Location Address: 1700 North SR 7

Explanation of Request: DEMOLISH EXISTING BUILDING AND CONSTRUCT A NEW RETAIL BUILDING AND PARKING LOT

RE: **Site Plan Review for a 4,000 sq. ft. commercial building (Al's Florist)**
File # 19-DP-27
SMA Project No. 2017-186

1 SITE PLAN
SP1.0 1" = 10'-0"

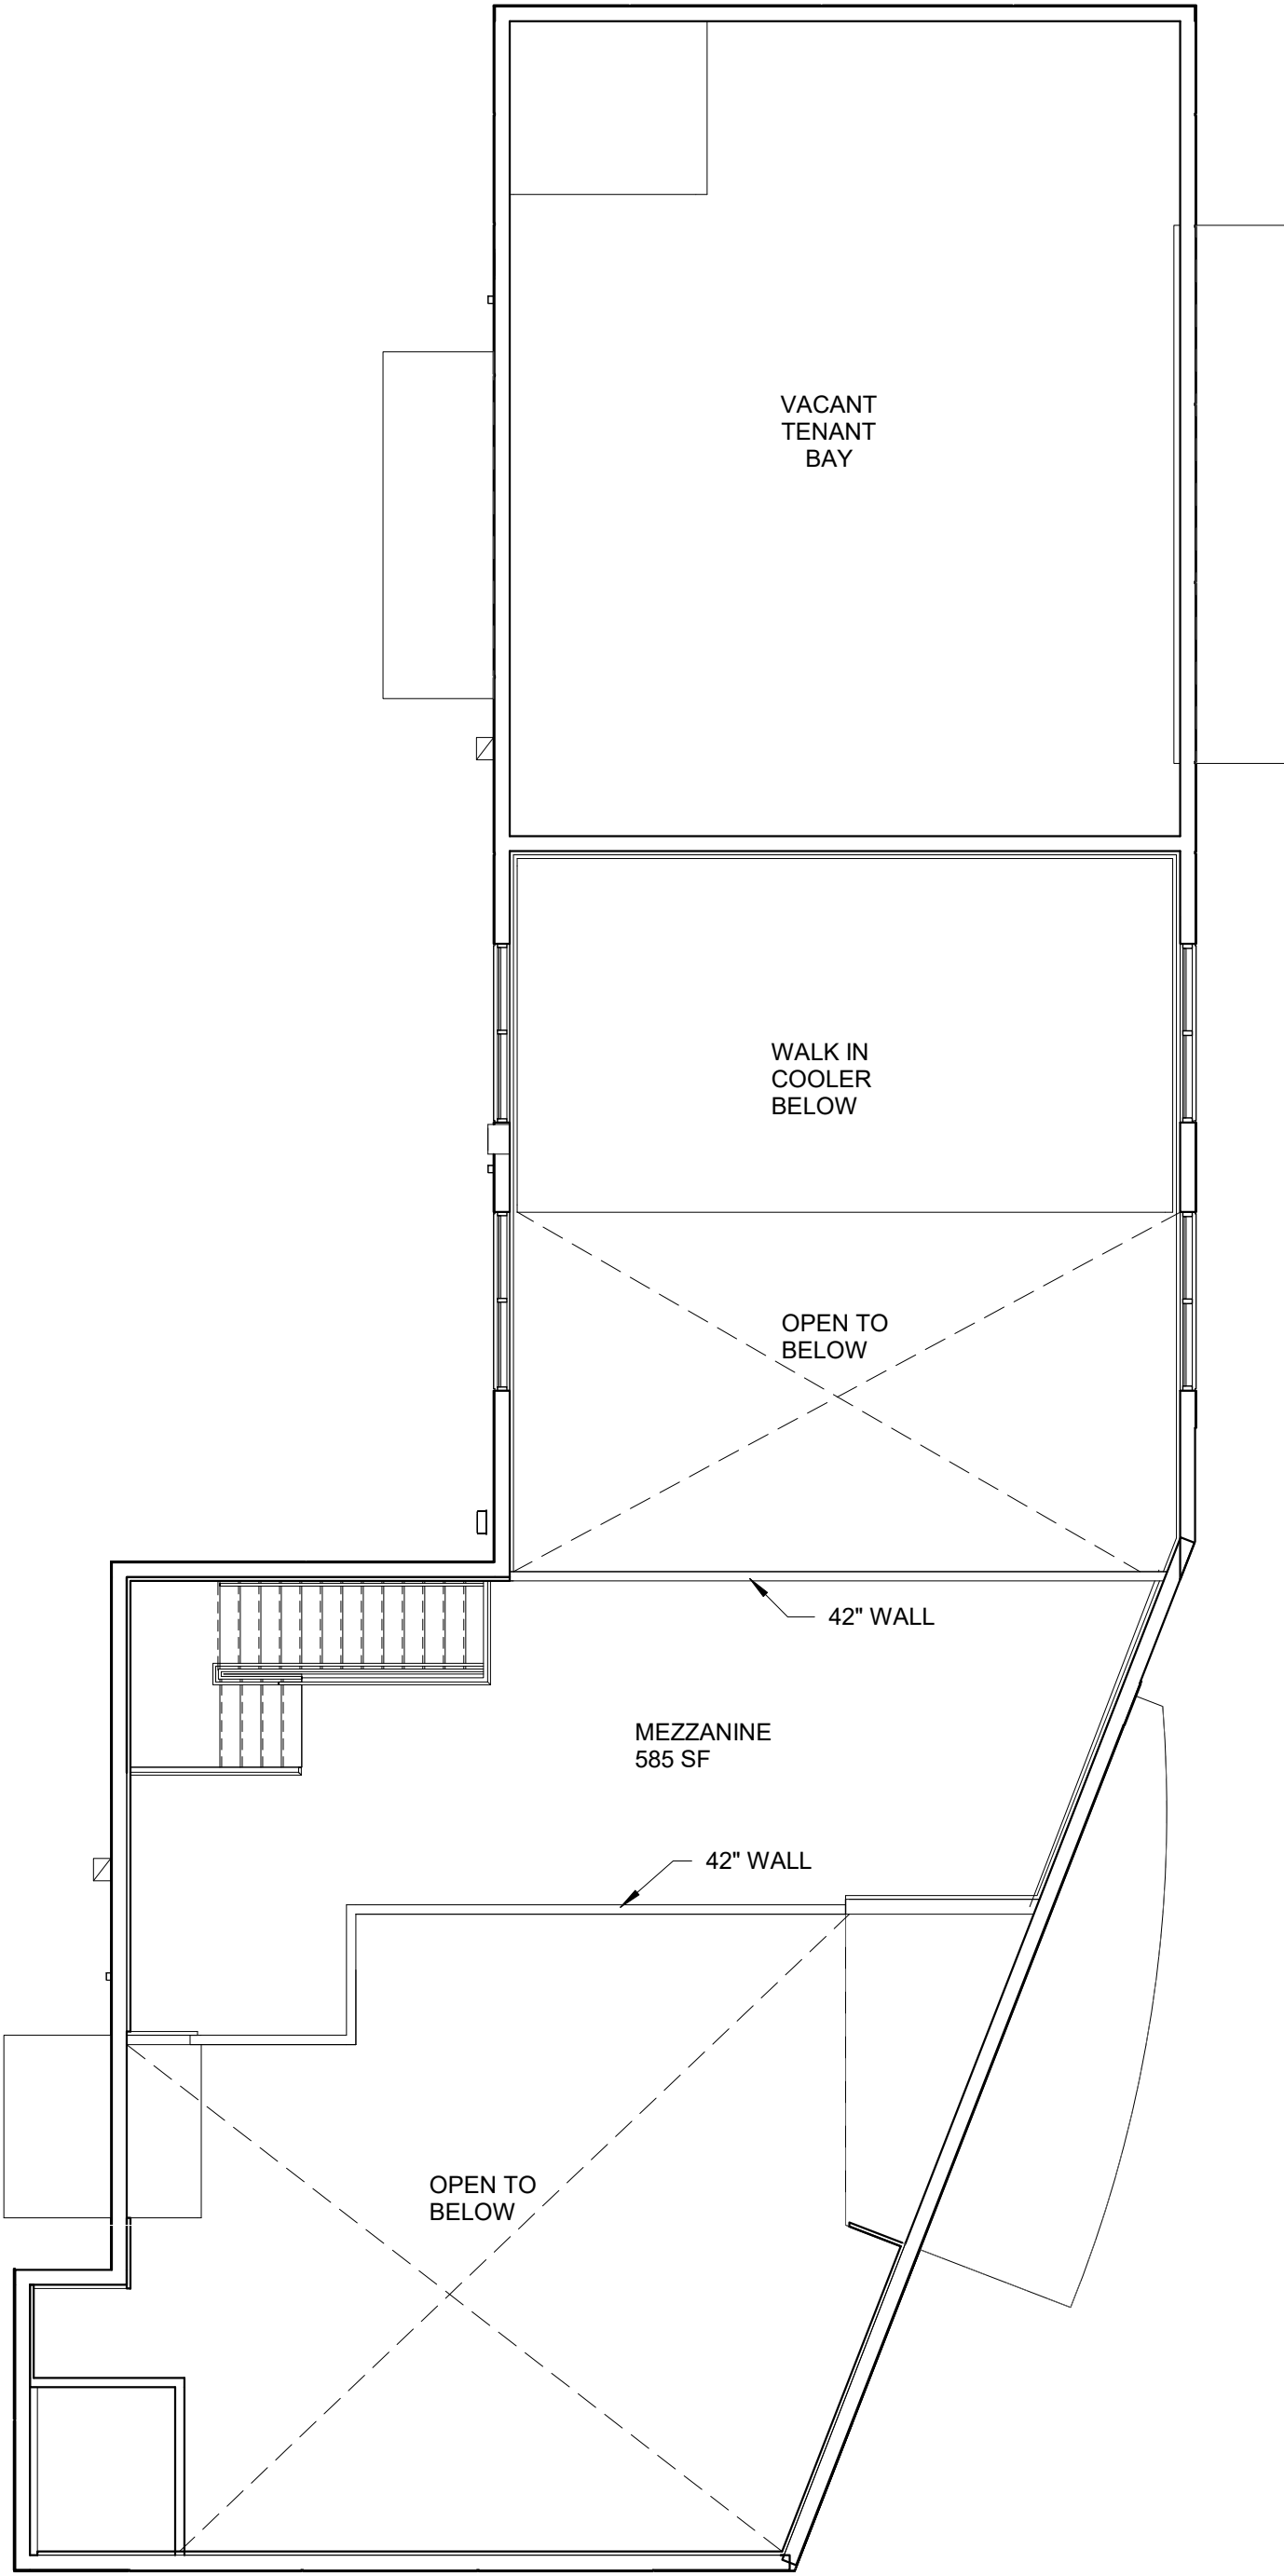
1. Comment: View triangle shall be measured from property line.

2. Comment: Ensure that adequate back out is provided in the parking area at the north end of the property. Back-out shall not encroach into required setback.

3. Comment: Minimum setback of drive aisle shall be three feet from the property line. Revise drawings accordingly.

4. Comment: Provide dimension of drive aisle not adjacent to parking area.

1. Comment: Include note on Site Plan stating the maximum foot-candle level at all property lines (maximum 0.5 allowed).
Response: *Note added as requested. Refer to Notes on sheet SP1.0.*

Response: *Updated as requested. Please refer to revised Sheet SP1.0.*

Response: *A back-out area has been provided on the northwest corner of the parking lot. Please refer to updated Sheet SP1.0.*

Response: *Updated as requested. Please refer to revised Sheet SP1.0.*

Response: *Updated as requested. Please refer to revised Sheet SP1.0.*

Light poles are shown on revised sheet SP1.0

Backflow preventer shown on revised sheet SP1.0

Awnings shown on revised sheet SP1.0

Traffic signal pole, boxes and electric boxes shown on revised sheet SP1.0

Response: *Mail is hand-delivered by the U.S. Postal Service. A note has been added under Notes on sheet SP1.0*

1
A1.0
GROUND FLOOR PLAN
1/8" = 1'-0"

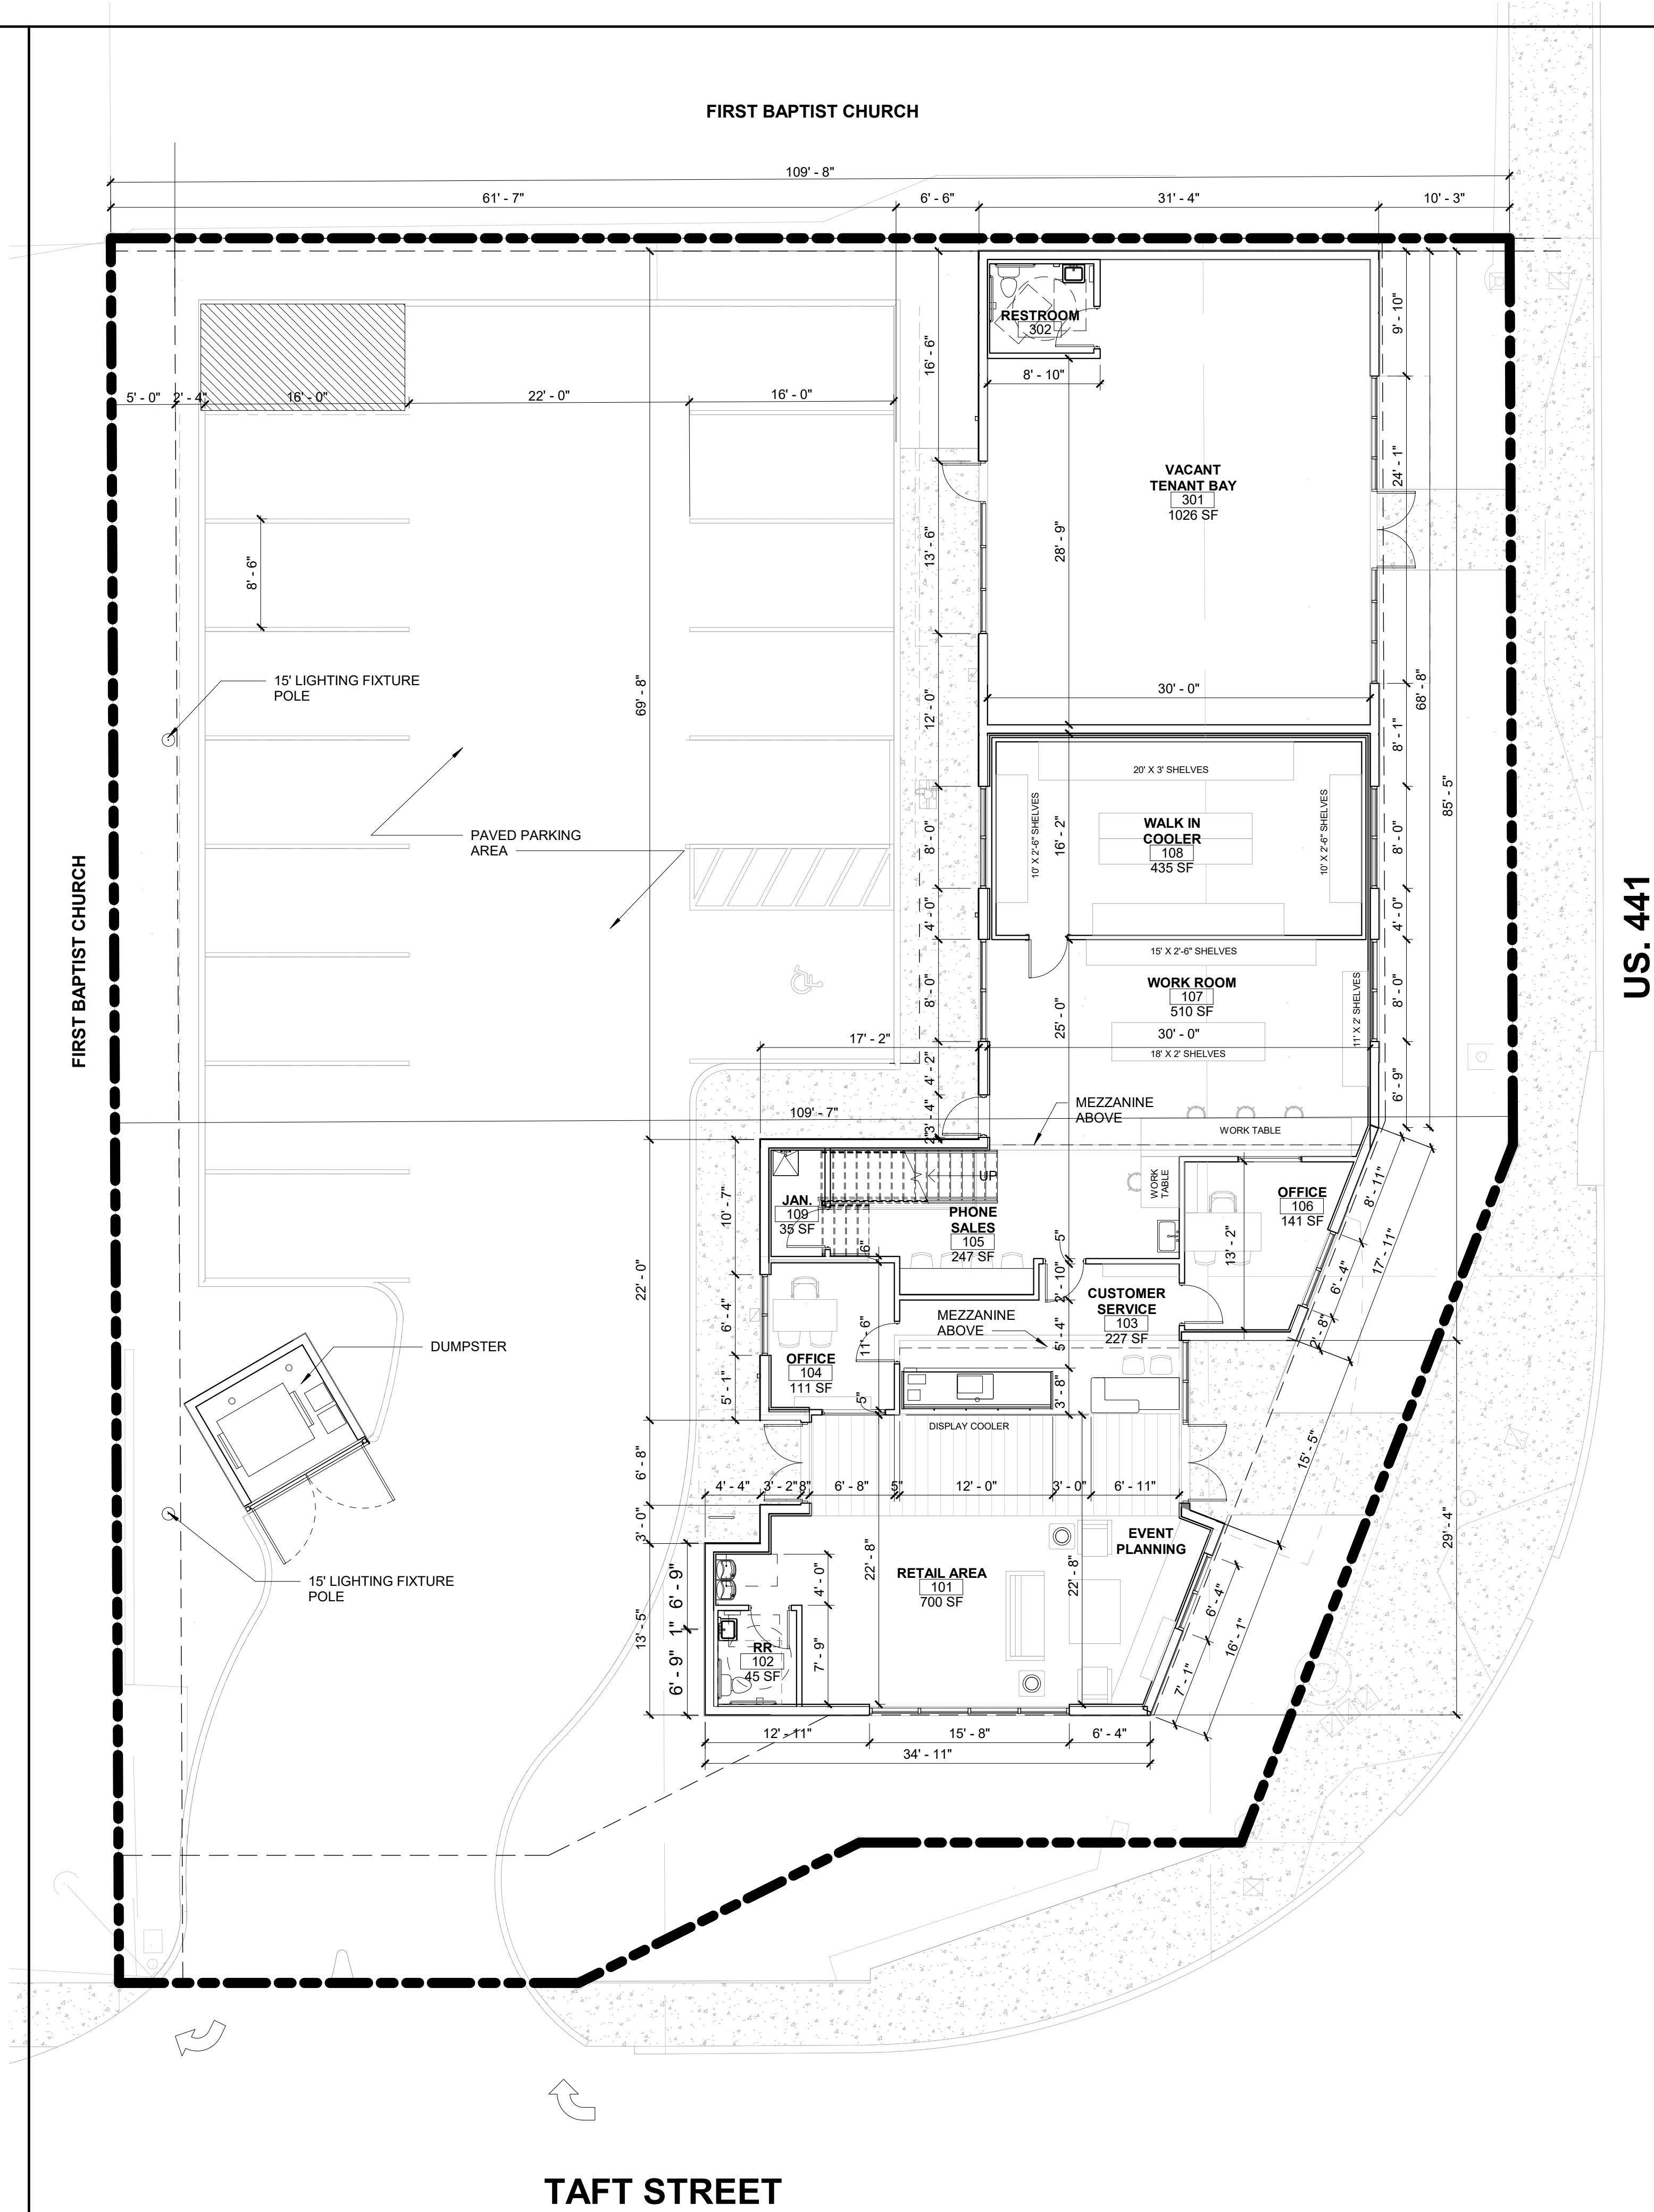
- c. Include required and provided active uses along State Road 7 and Taft Street.
- d. Include required and provided landscape open space.
- e. Provide site data for existing structure.
- f. Building height shall be measured to the top of the roof slab.
- g. Provide a total gross floor area of the building, including a breakdown of common areas (restrooms, power equipment rooms, and meter rooms).

- a. Please find the full legal description on sheet SP1.0*
- b. Data Table revised as requested*
- c. Use of adjacent properties on US441 and Taft are called out*
- d. Provided. Please refer to Site Data on Sheet SP1.0*
- e. Provided. Please refer to Site Data on Sheet SP1.0*
- f. Updated as requested. Please refer to Site Data on Sheet SP1.0*
- g. Updated as requested. Please refer to Site Data on Sheet A1.0*
